**Addendum #1**  
**2020 Roadway Improvement Project**  
**“Cambridge Drive Neighborhood”**  
**Bid No. 20-15**  
**Town of East Hartford**

**February 28, 2020**

The following summarizes the revisions to the Bid Documents included in Addendum #1 for the 2020 Roadway Improvement Project (Bid No. 20-15).

**CONCRETE DRIVEWAY RAMPS**  
N.T.S.

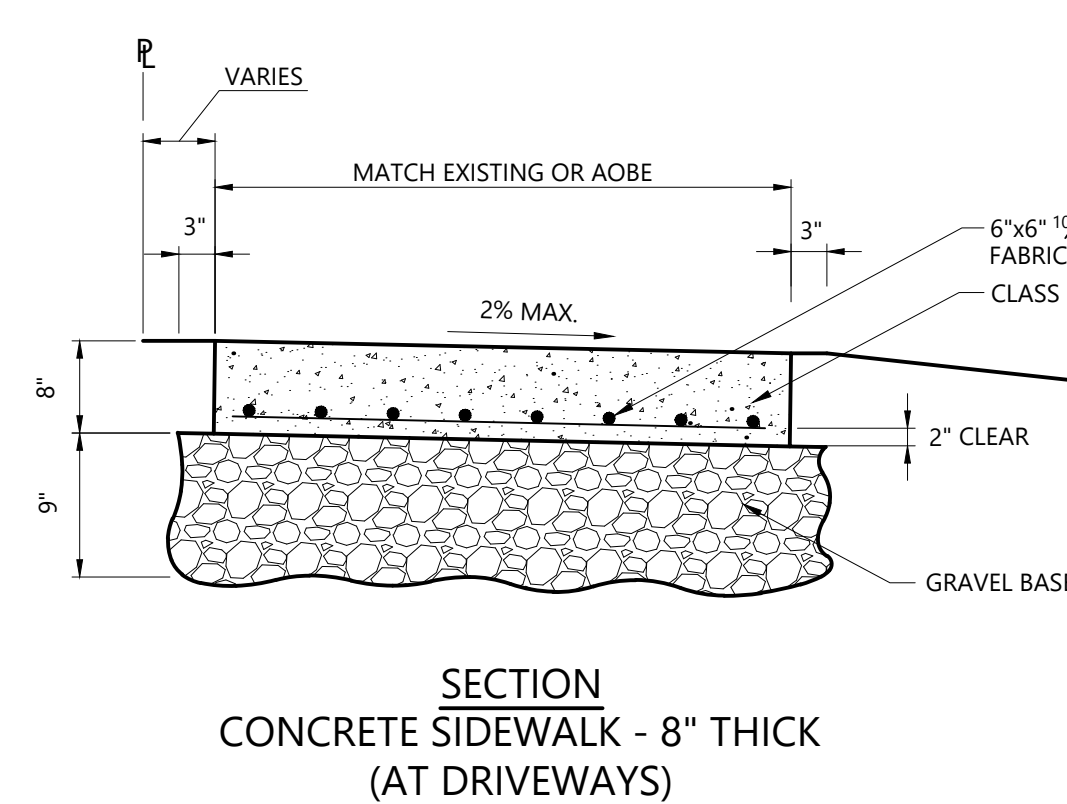
- Replace plan sheet 007 of 294 to reflect the addition of Gravel Driveway and Bituminous Concrete Snow Shelf details.

REV.	DATE	DESCRIPTION	SHEET NO.
02/25/20	ADDED CONSTRUCTION DETAILS		007

PROJECT NO.:  
42413.00  
DRAWING NO.:  
TIE-02  
SHEET NO.:  
069 OF 294

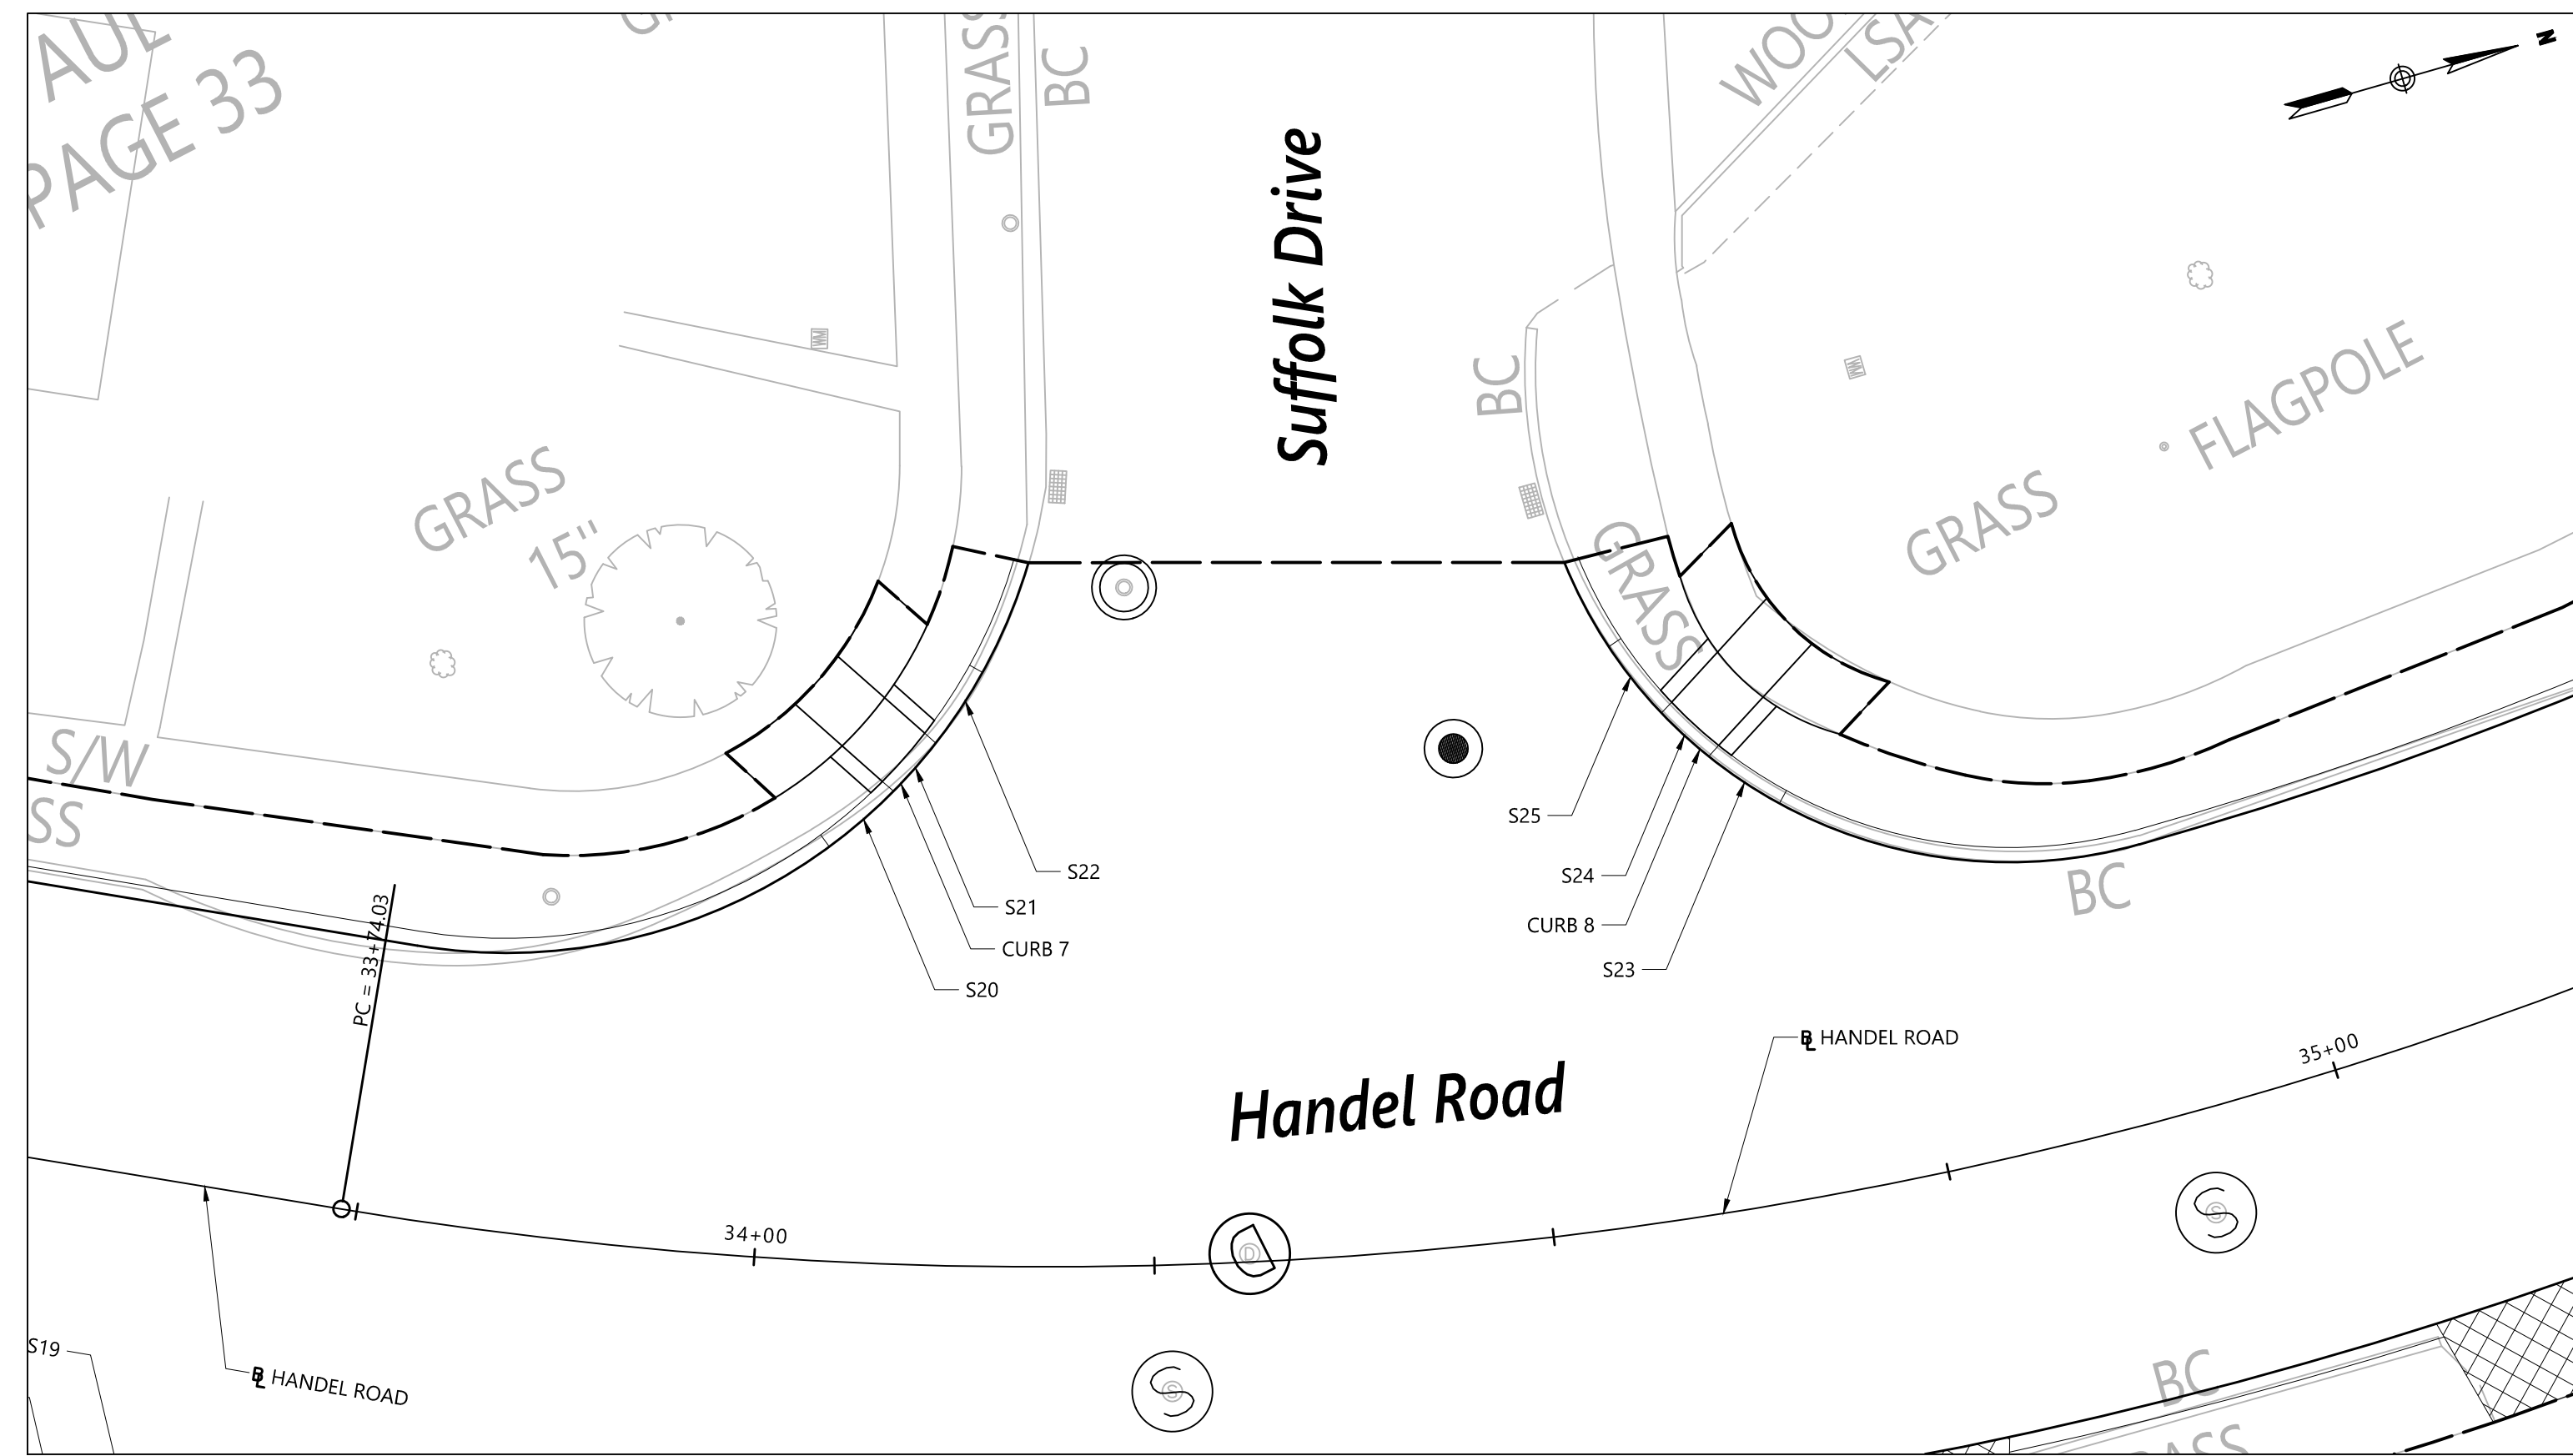
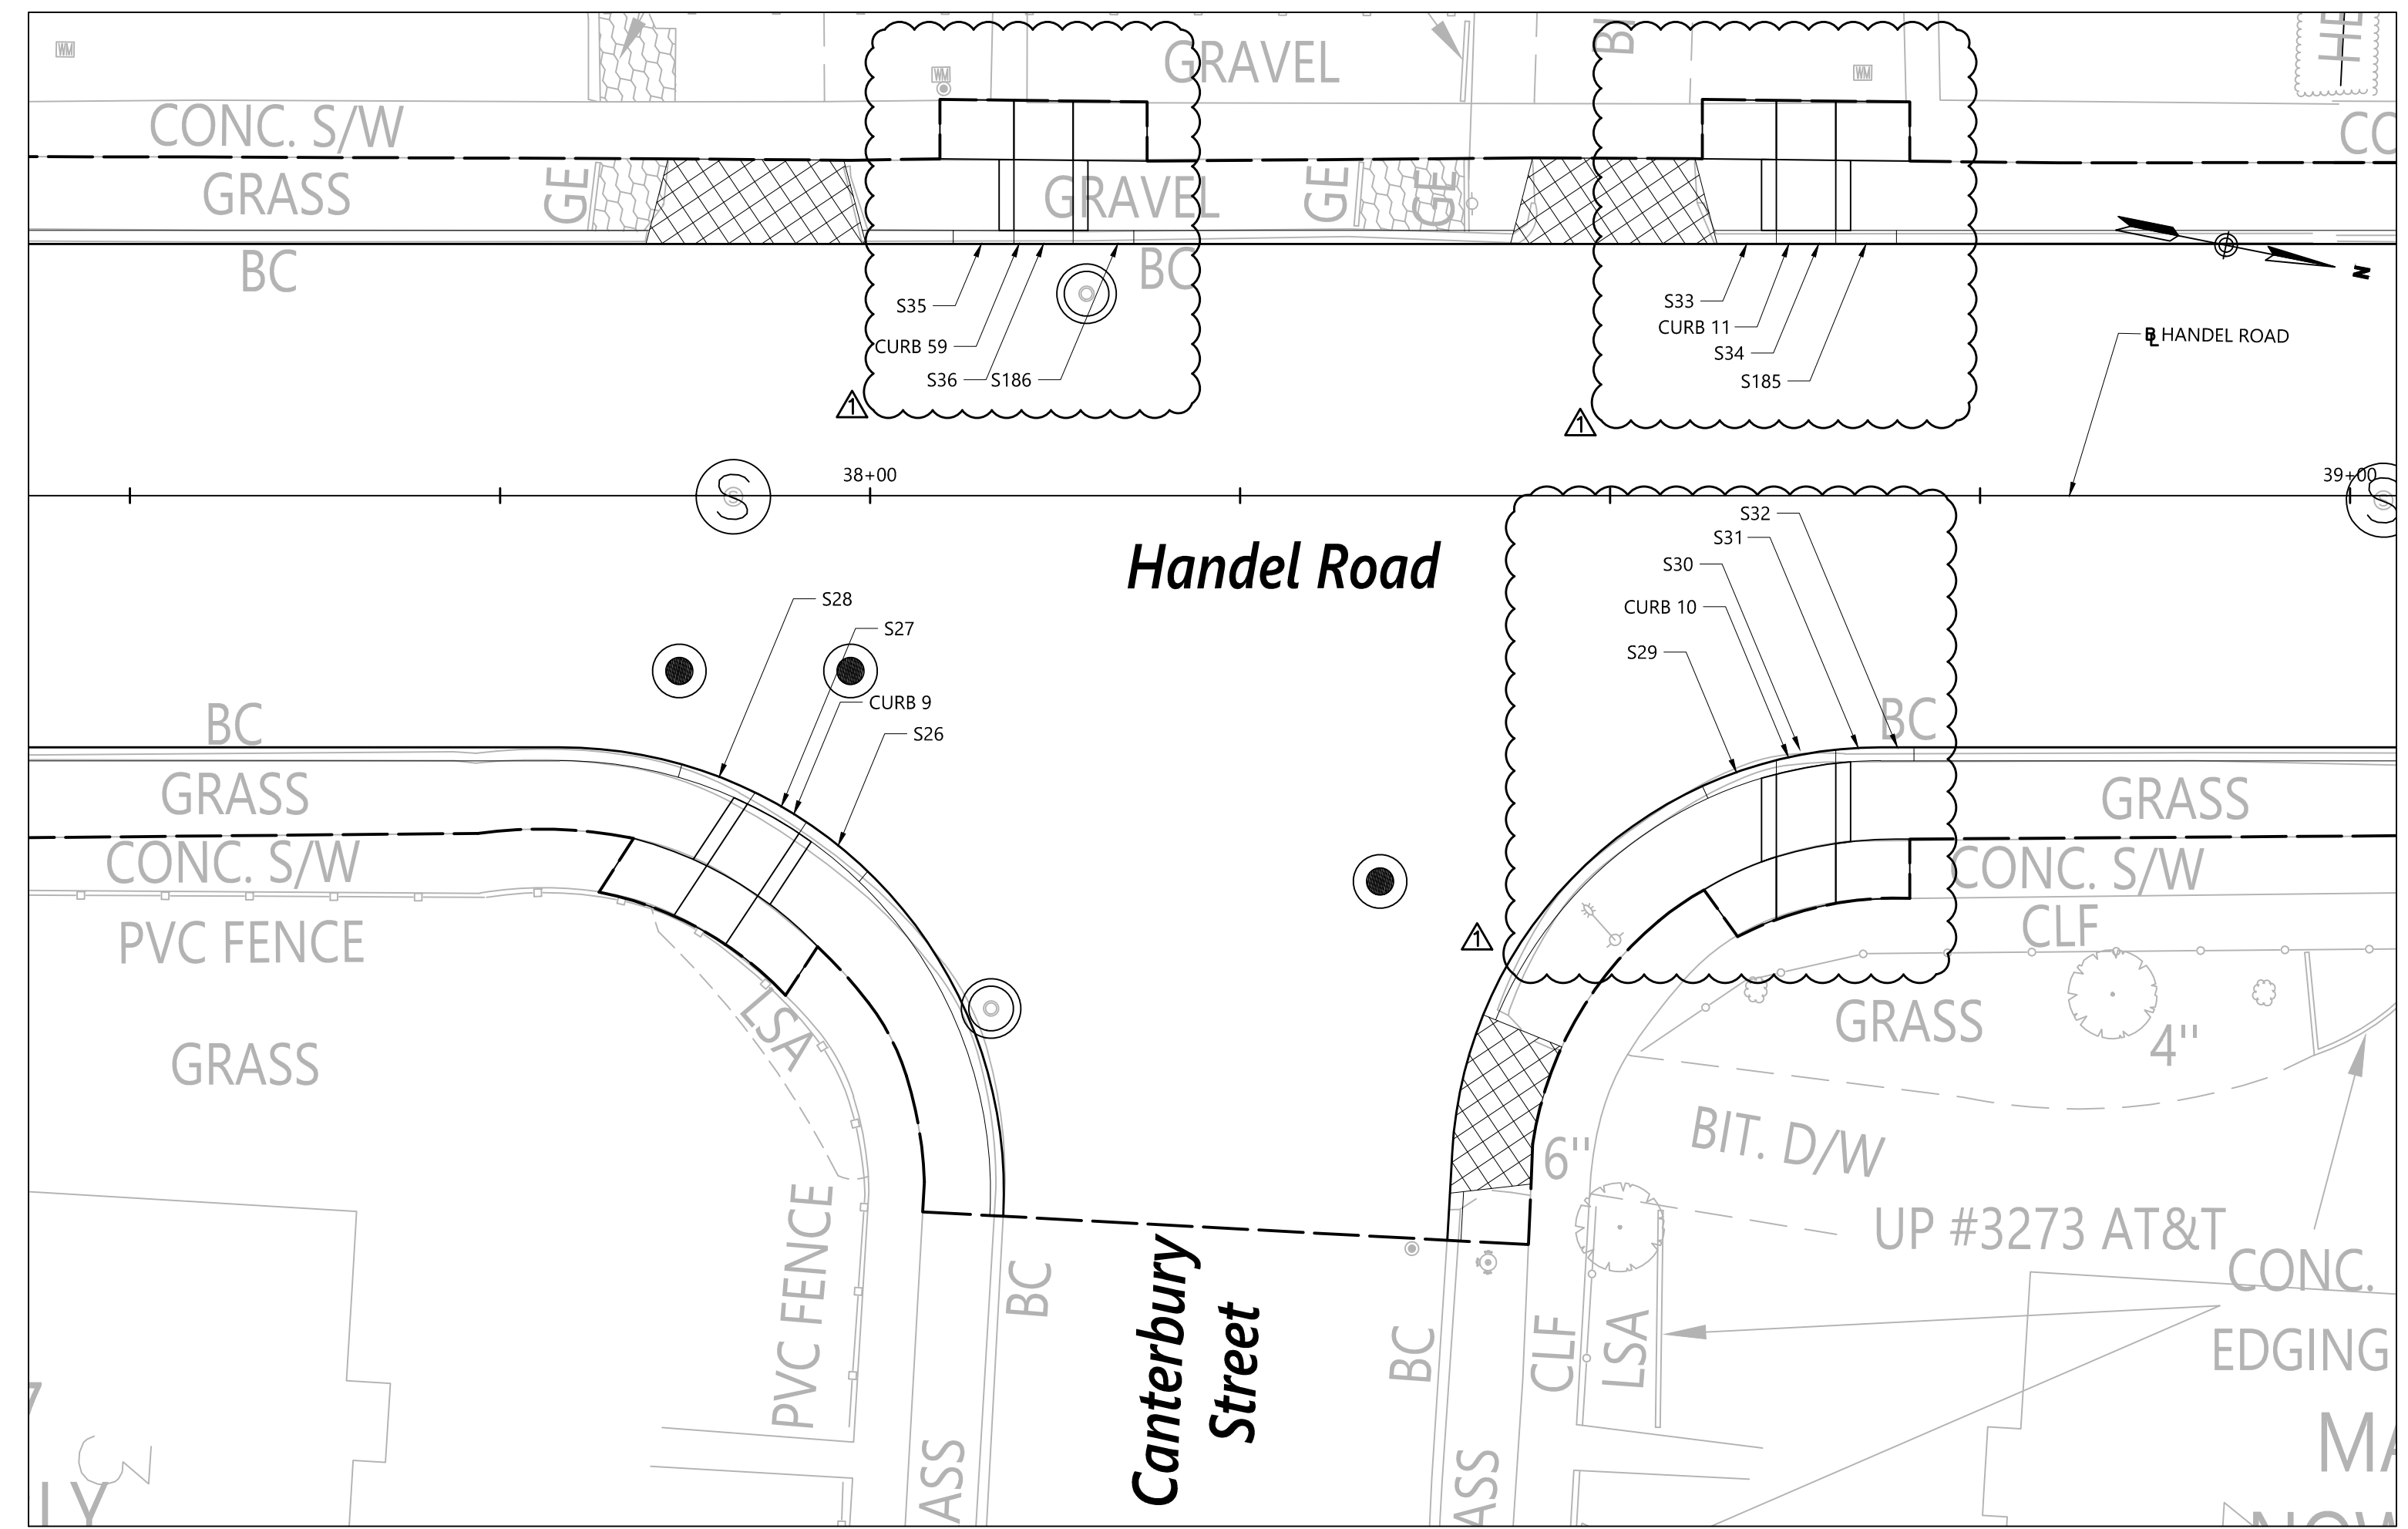
- Replace plan sheet 069 of 294 to reflect revisions to sidewalk ramp layout, curb layout, granite curb table, and calloffs.

REV.	DATE	DESCRIPTION	SHEET NO.
1	02/27/20	REVISED RAMP AND CURB LAYOUT, CURB TABLE, AND CALLOFFS	069
